**PUD &
SUBDIVISION STAFF REPORT****Date: July 7, 2005****DEVELOPMENT NAME** D'Iberville Town Homes**SUBDIVISION NAME** D'Iberville Town Homes**LOCATION** South side of Southland Drive, 800'± West of Knollwood Drive, extending to the West terminus of Southland Drive**CITY COUNCIL
DISTRICT** District 6**PRESENT ZONING** R-3, Multi-Family Residential**AREA OF PROPERTY** 10.8 Acres 58 Lots**CONTEMPLATED USE** Amend a previously approved planned unit development to allow reduced lot size, widths, reduced building setbacks, increased site coverage, and on-street shared parking for a single-family residential town home subdivision.**TIME SCHEDULE
FOR DEVELOPMENT** Phase One — Immediately upon approval**ENGINEERING
COMMENTS** Must comply with all stormwater and flood control ordinances. Any work performed in the right of way will require a right of way permit.

Revised for August 4, 2005

SITE PLAN

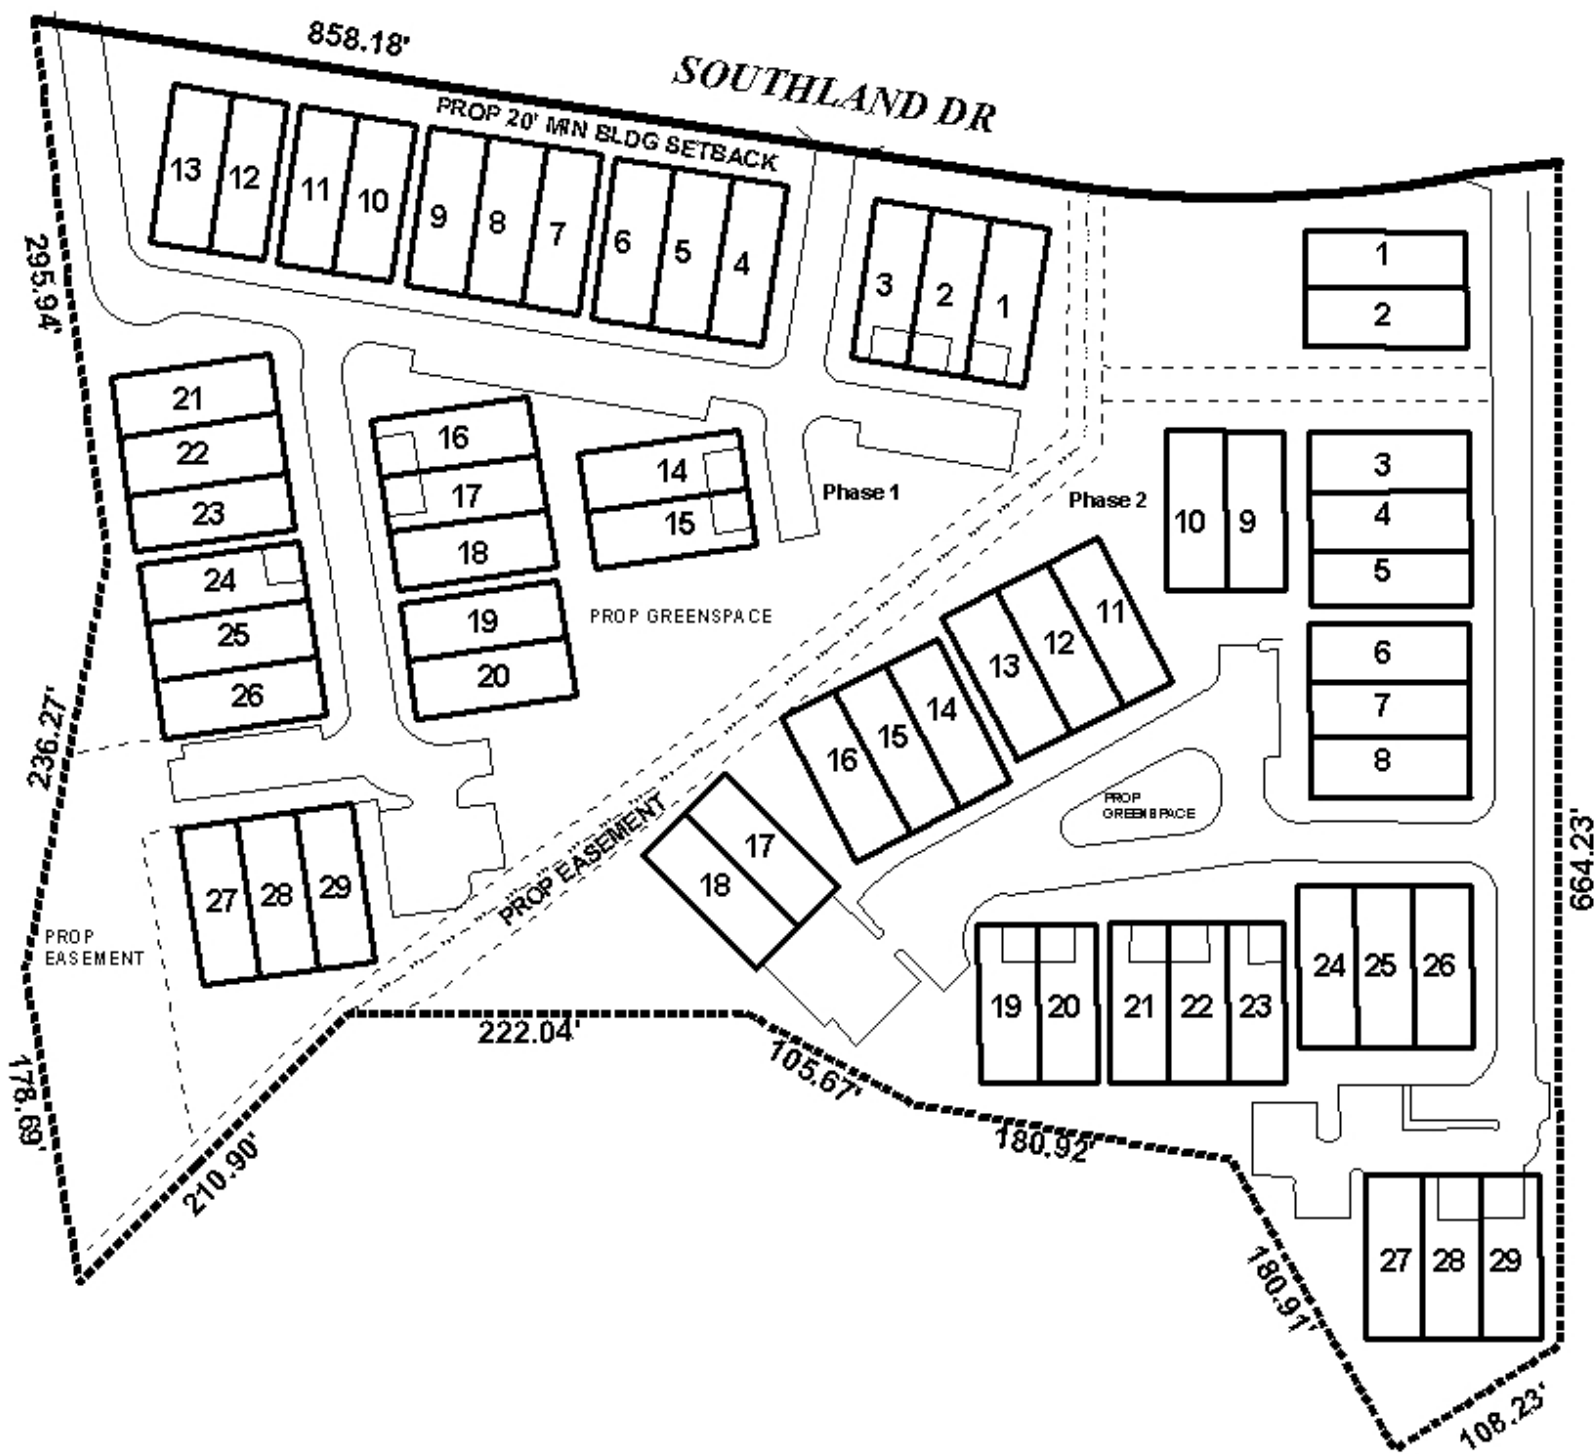
Roadway layout appears not to be City standard. Some cul-de-sacs do not have adequate ROW specified and curbing stated ("role-back") is not City standard. If streets are to be dedicated to and maintained by the COM, they must be constructed to City of Mobile standards.

Driveway number, size, location, and design to be approved by Traffic Engineering and conform to AASHTO standards. Head in parking that requires backing into the travel way is not allowed. Although right-of-way widths are shown, actual street widths are not given on the drawing and in some instances are not shown. Without this information, it cannot be determined if the shown turnarounds are adequate.

Revised Traffic Engineering Comments: Driveway number, size, location, and design to be approved by Traffic Engineering and conform to AASHTO standards. Traffic Engineering would prefer that the proposed turnaround be changed to standard cul-de-sacs. A standard cul-de-sac is easily recognized by drivers and will avoid any potential confusion. The extra guest parking at the end of streets (non parallel) should be accommodated in standard parking lot layouts.

Roadway layout appears not to be City standard. Some cul-de-sacs do not have adequate ROW specified and curbing stated ("role-back") is not City standard. If streets are to be dedicated to and maintained by the COM, they must be constructed to City of Mobile standards.

Site has been cleared without benefit of permit. Please provide appropriate erosion control measures.

Comments: *The applicant has submitted a revised site plan that addresses some of the concerns referenced in the original staff report and comments from other departments, such as better delineation of the parallel parking along the proposed streets and dimensioning of the proposed street improvements, exclusive of the proposed parallel parking (22' clear). The plan also proposes "hammerhead" type turnarounds in several locations to allow for maneuvering of fire trucks and other emergency vehicles. These turnarounds replace previously proposed cul de sacs and eliminate some of the parking that backs into the right-of-way, but not all. Additionally, based upon discussion with Fire Department personnel, there appears to be some question with regard to the functionality of the apparatus turnaround located on the Southeast portion of the site.*

Revised Comments from Traffic Engineering indicate that the full cul de sacs would be preferable, and that guest parking facilities proposed at the end of turn arounds (not parallel) should be provided in the form of standard parking lots layouts.

In concept, the plan could be considered innovative. However, as stated in the original report, PUD approval is site plan specific. Given the concerns regarding parking facility design, Traffic Engineering preference for cul de sacs, and Fire Department concern regarding the functionality of the turnaround in the Southeast portion of the site, approval of the plan as submitted would not be appropriate due to the number of modifications required. Additionally, as stated in the original Engineering Comments, the construction standard stated in the original application is not city standard.

REVISED RECOMMENDATION PUD: *Based upon the preceding, it is recommended that this application be heldover until the September 1, 2005 meeting. Any revisions or additional information must be submitted by August 15.*

Subdivision: *Based upon the preceding, it is recommended that this application be heldover until the September 1, 2005 meeting. Any revisions or additional information must be submitted by August 15.*
